Staff Report

Logan's Landing Appeal

Land Use Application Nos.:	SPR 22-001 (Site Plan Review), CAP 22-001 (Critical Areas Permit), SEP 22-003 (SEPA Checklist) Now: WLD-2023-006
Applicant & Property Owner:	Belmont-Lewis Holdings, LLC Attn. Shayne Olsen PO Box 1940 Bend, Oregon 97709
Additional Representative:	Wyndham Enterprises, LLC Attn. Ed and Judy Greer 13023 NE Hwy 99, STE 7-126 Vancouver, WA 98686
Site Location:	Franklin Loop off of Belmont Loop in Woodland, WA 98674.
Parcel No. & Size:	50680023, 50729, and 50730. Parcel 50714 will also be impacted. Approximately 20 acres.
Zoning Designation:	Highway Commercial (C-2), Light Industrial (I-1)
Notice of Complete Application Issued:	Last submittal on August 22 nd , 2023
Notice of Application & Likely DNS issued:	NOA issued September 6, 2023

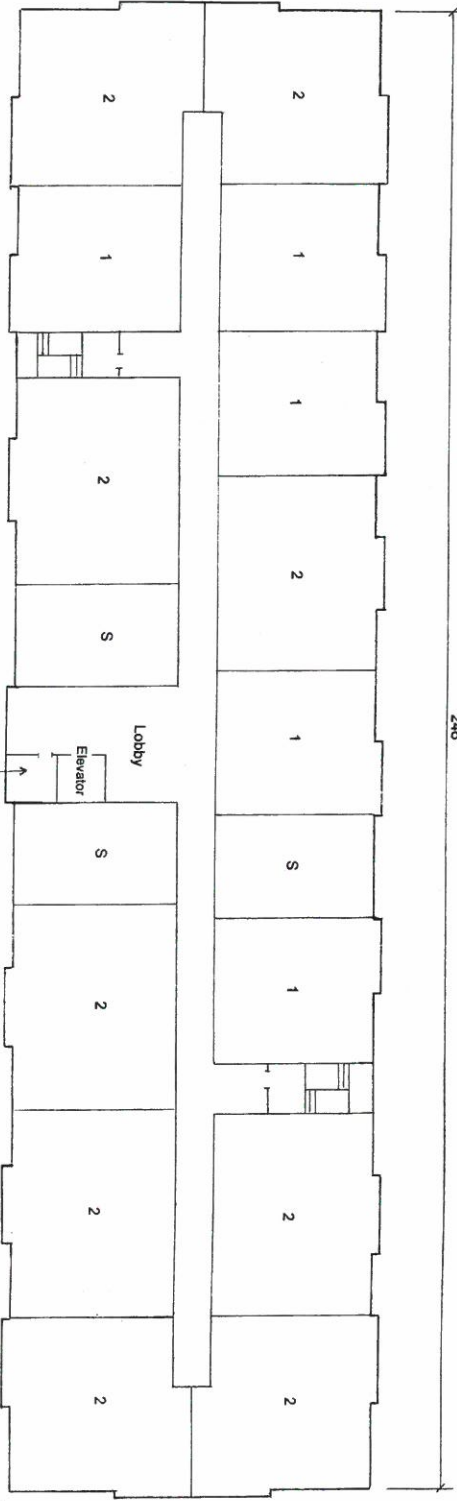
Instead of making the change as requested when this issue was raised upon the first application submittal, and the applicant revised their buildings plans to go from 972

square feet of commercial space per building (see Attachment A) to the current proposal of 5,080 square feet of commercial space (see Attachment B). While this may not be a de facto admission of staff's argument, it appears to recognize the argument because there was also a corresponding reduction of parking spaces from approximately 38 parking spaces to 21 parking spaces. But there is presumably still residential development above the parking spaces, not just the commercial use space.

The revised plans also went from three-stories of residential use, to two-stories of residential use. Presumably because there was not enough parking on the site to accommodate parking for commercial spaces in the building.

It appears that the only way to add space in the building for commercial uses (in the commercial zone), was to eliminate residential units and thus free up the residential parking spaces intended for those units. This would seem to be supported by the fact that there is virtually no change between the first site plan design, and the second site plan design. In my opinion, that shows that the design was intended for a residential apartment building and that they had to modify the building plans simply to accommodate commercial uses to make it look like a mixed-use in the commercial zone.

Plan for Ground Floor

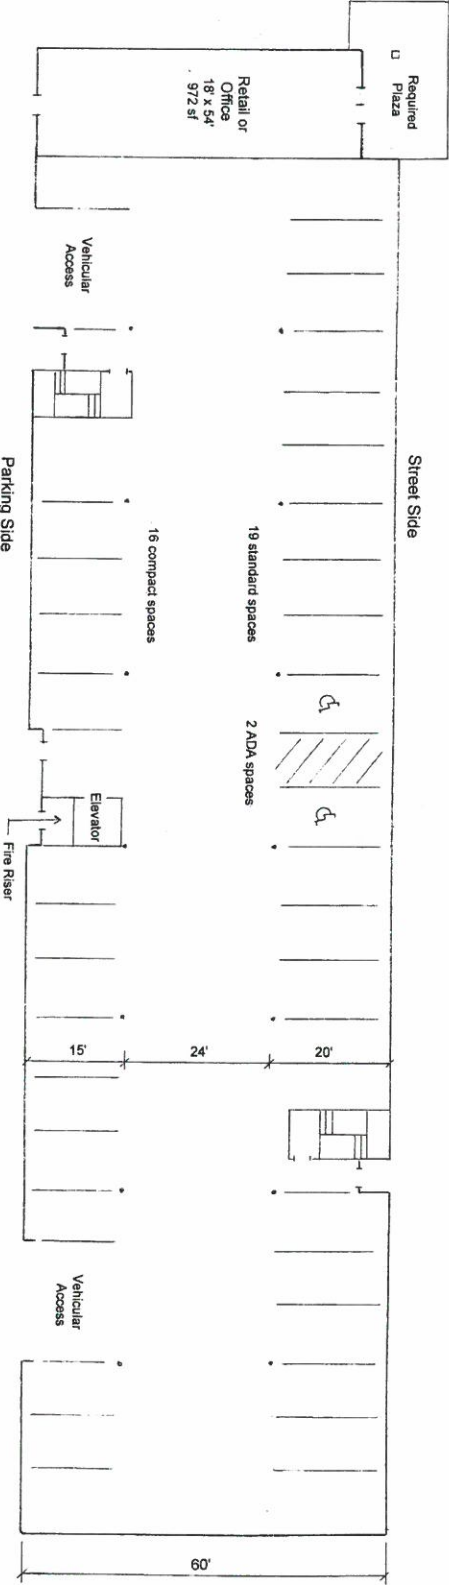
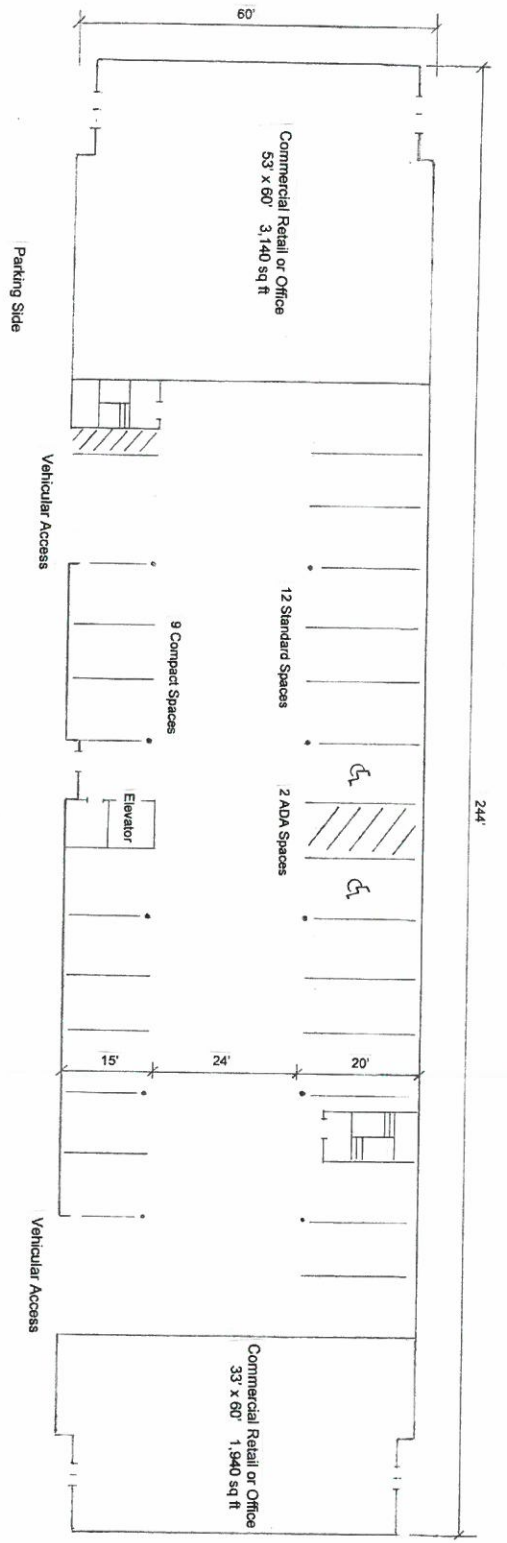
Staff has to concludes that the applicant is counting on using the in-building parking to provide spaces for commercial uses. (Possibly making them commercial parking spaces as opposed to a commercial parking facility? Otherwise, the residential parking on the bottom floor wouldn't meet the "residential above a commercial use" standard.)

The problem with that is the ADA spaces are clearly positioned to provide access to the residential elevators and not for the commercial spaces. In fact, the applicant points out that the plaza entries to the commercial uses are at the outside corners of the building. If the internal parking spaces could be restricted to serve the commercial uses, the entrances to the commercial spaces would enter internally to the garage and not outwards at the remotest corners of building, far from the ADA spaces. The design isn't conducive to ADA access to any of the commercial space.

This clearly seems to imply that the in-building parking is intended to serve as private parking for residential use. And again, if it's residential parking, it can't be considered as a "commercial use" and therefore can't have residential above it. (Finding #28)

There is barely enough site plan information to clearly identify the entries of the commercial spaces. And if you can identify them, it's hard to even evaluate whether there are adequate ADA spaces that meet the standards for the commercial uses. Again, the site plan appears to locate all the ADA spaces where they can best access the residential elevator. Another design consideration that implies the building will be for all practical purposes a residential building and not commercial.
